### **Addendum Number Three**

To The Drawings and Specifications for  
Ottawa Travel Center for J&J Development  
Ottawa, Kansas

Issued: October 9, 2008

### **HANNEY & ASSOCIATES ARCHITECTS**

**SOUND BOX DETAIL**

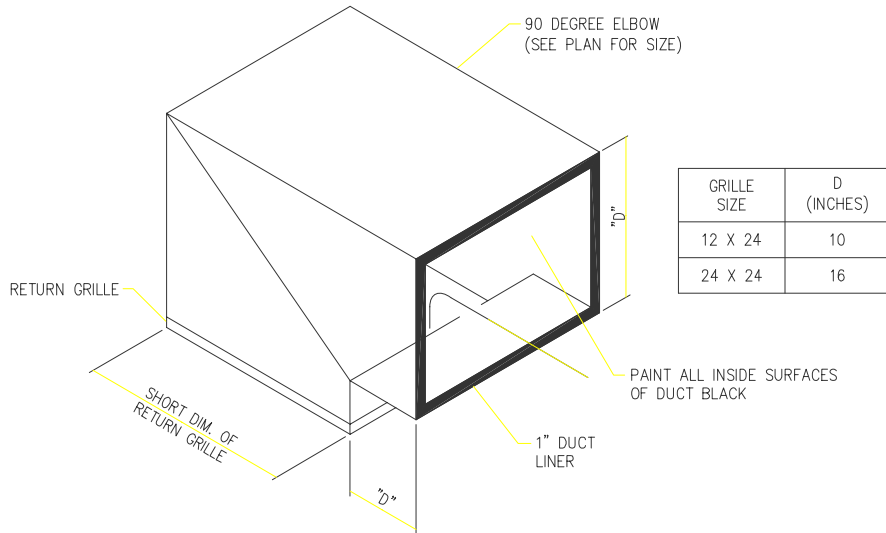
- 4.3 All return air grilles open to plenum shall be installed with return air sound boot.
